SERVICE LETTER SL-28

SUBJECT: D040-1 aft cowling assembly

ROTORCRAFT AFFECTED: R44 & R44 II helicopters

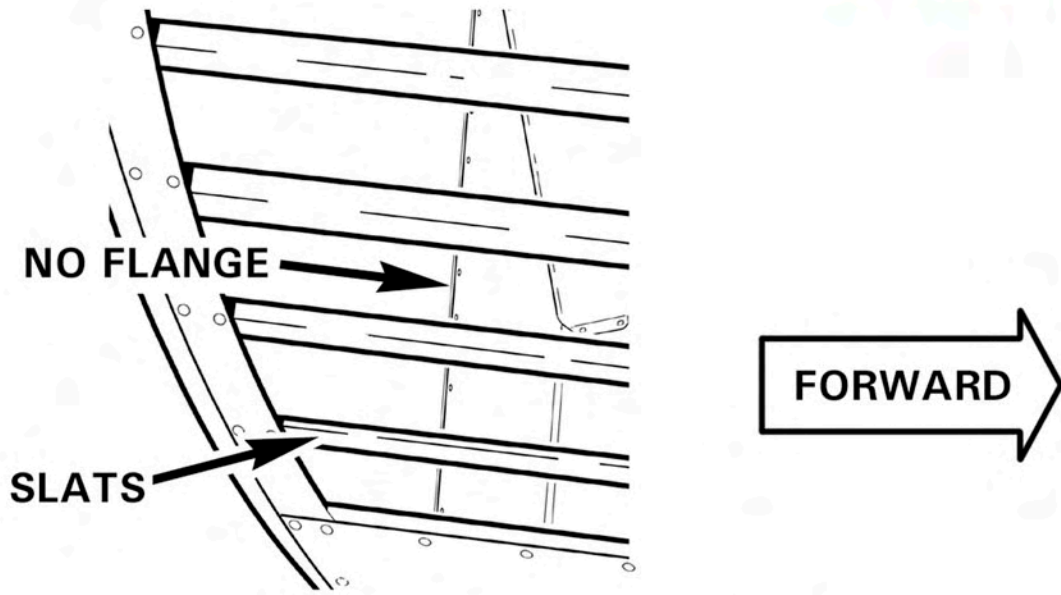
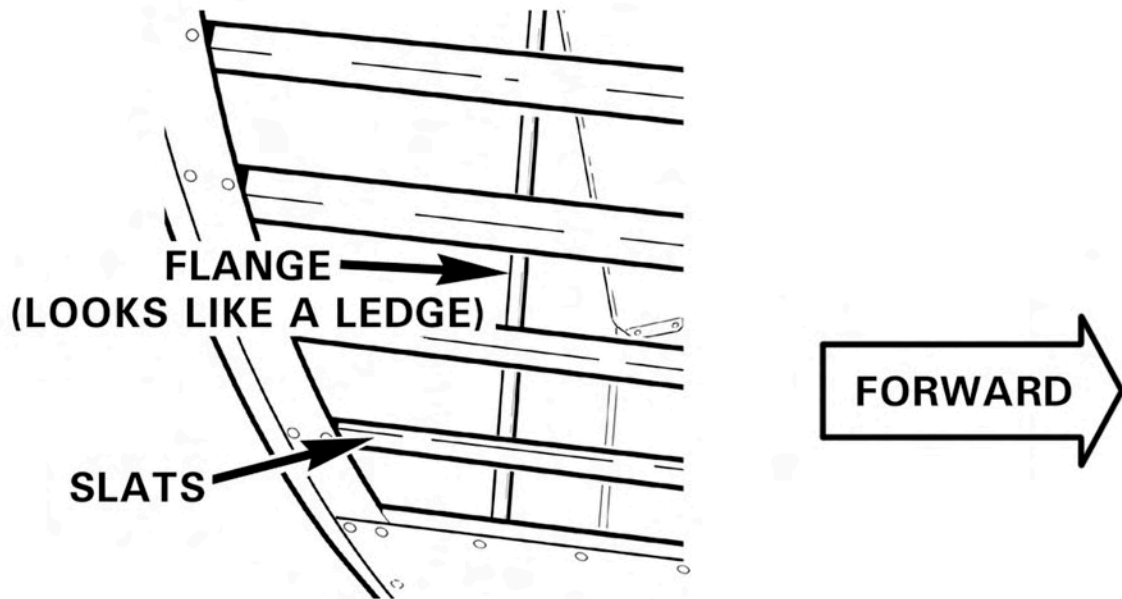
BACKGROUND: RHC has received reports of the D040-1 aft cowling's aft, lower aluminum panel cracking. To increase panel flexibility and thereby reduce cracking, later cowling assemblies deleted the stiffening flange between the upper and lower aft panels. Cutting off flange on earlier revision panels will help prevent cracking.

1. Refer to Figures on reverse. Look thru aft cowling's cooling air inlet slats and visually inspect lower aft panel for flange. If flange is present, remove aft cowling.
2. Carefully cut off flange. A powered, high-speed cut-off wheel may be used provided panels are protected from damage via suitably positioned pieces of sheet metal.
3. Blend sharp edges.
4. Inspect panel, especially at edges, for cracks. Minor cracks may be stop-drilled and repaired with doubler(s) in accordance U.S. FAA AC 43.13-1B.
5. Touch-up bare metal with zinc-chromate or epoxy primer.
6. Install cowling.
7. Make appropriate maintenance record entries.
